4A Yarn Dyeing Ltd.

Kaichabari, Savar, Dhaka-1340, Bangladesh
(23.945831, 90.261923)

25 March 2014

Observations

Typical Column Layout

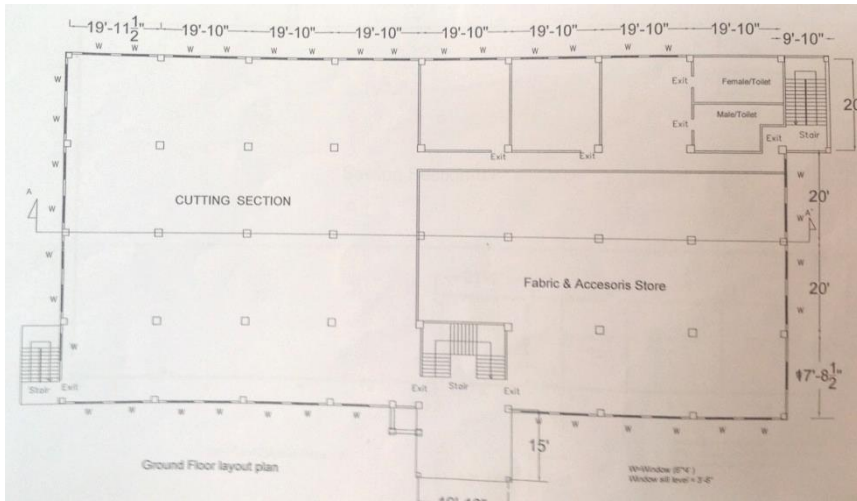
Highly stressed columns

Outline calculations indicate that the working stresses of columns are at a high level.

Building Engineer to check that columns have been designed to accommodate applied loads including roof extension and heavy finishes.

Brick aggregate observed.

Tested column at lower floors - Brick aggregate observed.

Item No.	Observation	Recommended Action Plan	Recommended Timeline
1	Highly stressed columns	Factory Engineer to review design, loads and columns stresses including any additional loading as documented in the observations chapter.	6-weeks
2	Highly stressed columns	Verify insitu concrete stresses either by 100mm diameter cores or existing cylinder strength data for cores from minimum 4 columns.	6-weeks
3	Highly stressed columns	Produce and actively manage a loading plan for all floor plates within the factory giving consideration to floor capacity and column capacity.	6-months
4	Undocumented vertical extensions	The Building Engineer should check the load plans and confirm that the main building structure is capable of safely supporting the additional loading on the structure from the roof extension.	6-weeks
5	Undocumented vertical extensions	Building Engineer to provide detailed calculations for the temporary rooftop structures and the associated light steel roofs. These should confirm their ability to withstand all wind loading pressure, suctions and uplift forces.	6-months

Vertical Extension

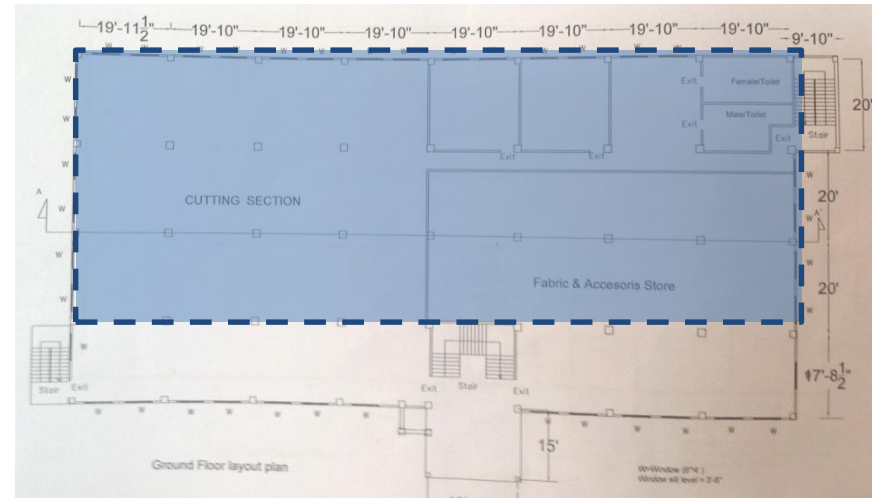
Vertical extension on roof, comprising brick masonry walls with a lightweight steel trussed roof on Building 1. No evidence of horizontal bracing.

No structural or design documentation provided for extension. Subject to uplifting forces.

Evidence of previous storage at roof level.

6	Undocumented vertical extensions	Building engineer to check, collect information and produce accurate and complete as-built documentation.	6-months

Localised areas of high loading

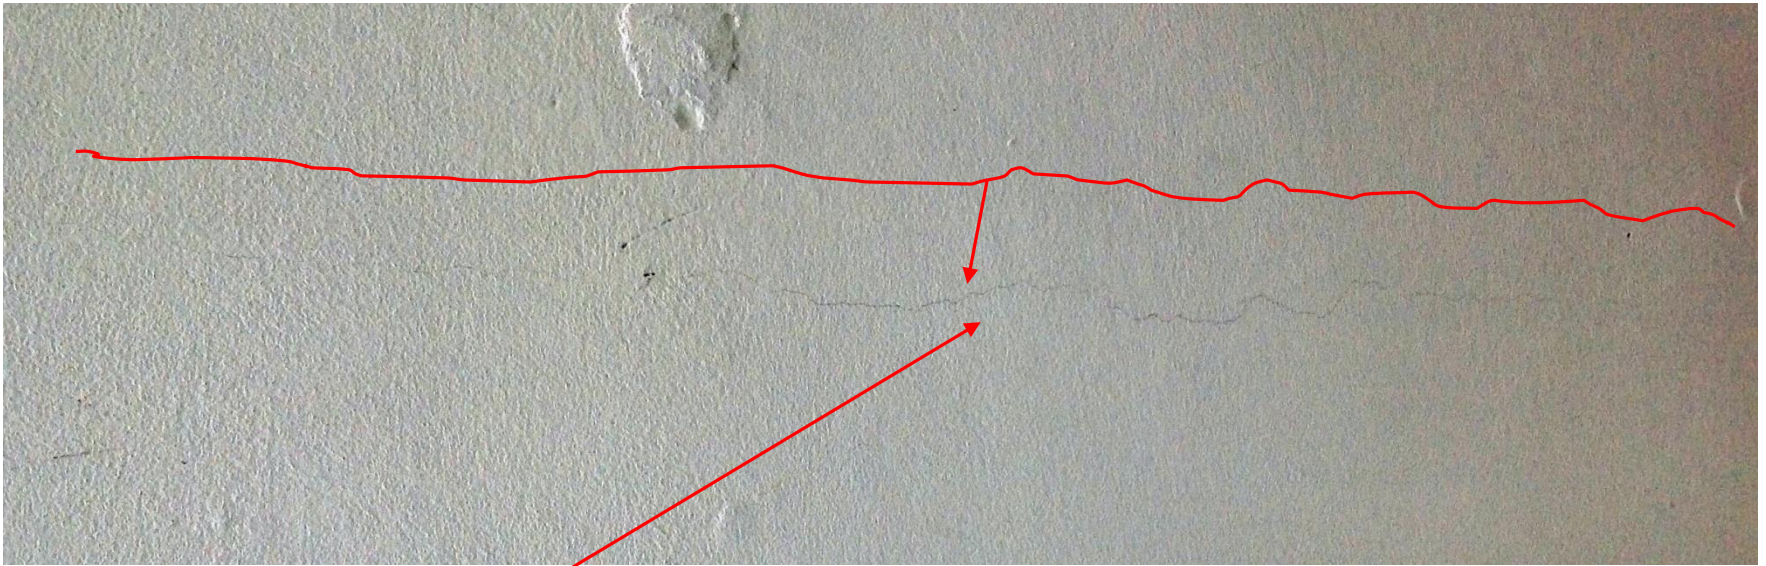
Typical toilet block.

Increased floor build-up in toilet block areas (~150-200mm in cubicles).

Partition walls around block and between additional cubicles

Additional approx. 100mm thick concrete ceiling above toilet blocks.

Water tank storage at roof level

Tank storage

Empty storage at roof level

Empty storage area observed at roof level.

12	Localised areas of high loading in all buildings	Produce and actively manage a loading plan for all floor plates within the factory giving consideration to floor capacity and column capacity. Loading plans to be put on each factory floor.	6-months

Location of partition wall at level 2 and crack in slab below

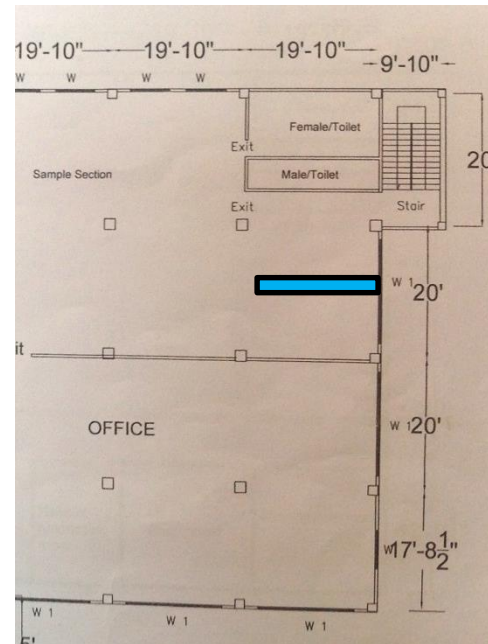
Full height brick partitions supported directly on flat slab structure in a number of locations.

Full height partition supported from regular flat slab structure.

Cracking in slab below full-height partition

Crack on surface of slab soffit observed at level 1 directly below line of full height brick partition in level 2.

Crack in soffit of slab below full-height partition

Factory engineer to check adequacy of flat slab structure for as-built brick partitions.

Item No.	Observation	Recommended Action Plan	Recommended Timeline
7	Cracking in slab below full-height partition	Flat slab capacity to be assessed for additional loading due to brick partitions, and extent of cracking within slab depth to be investigated.	6-weeks
8	Cracking in slab below full-height partition	Remove partitions if required by design check	6-months
9	Cracking in slab below full-height partition	Repair slab if required following investigation of crack	6-months
10	Cracking in slab below full-height partition	Design check of building required prior to installing any new brick partition walls.	6-months
11	Localised areas of high loading in all buildings	Extent of build-up loading in toilet and wash areas to be surveyed and weight of water tanks on roof to be assessed. The capacity of floor & roof slabs to be assessed to confirm that the structure is designed to carry these loads.	6-weeks

Unrestrained parapet at roof level

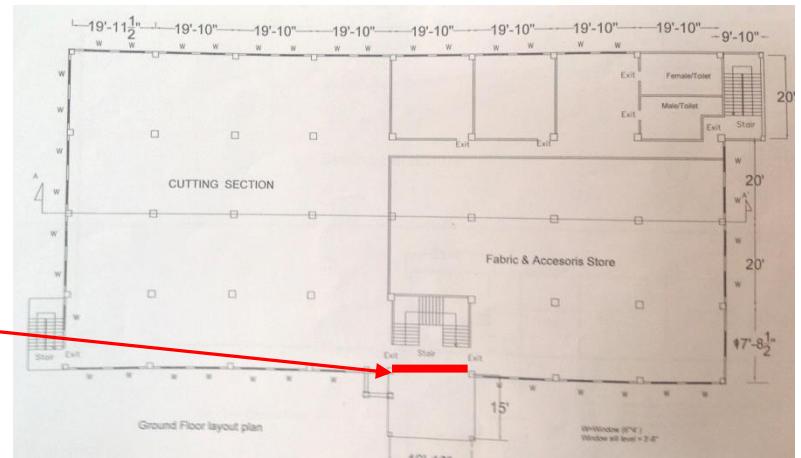
Location of parapet adjacent to water tank storage.

Roof parapet in the water tank storage area observed to be unrestrained and out of plumb.

Unrestrained parapet at roof level

Item No.	Observation	Recommended Action Plan	Recommended Timeline
13	Unrestrained parapet at roof level	Building engineer to assess stability of the roof partitions.	6-weeks
14	Unrestrained parapet at roof level	Repairs to be carried out as required by engineering assessment.	6-months
15	Undocumented single storey industrial and utility buildings	Building Engineer to verify that building has an appropriate lateral stability system and submit relevant design document	6-weeks
16	Undocumented single storey industrial and utility buildings	Carry out remedial work if required.	6-months
17	Undocumented single storey industrial and utility buildings	Building engineer to assess single storey utility building and confirm its ability to withstand all wind loading pressure, suctions and uplift forces	6-months
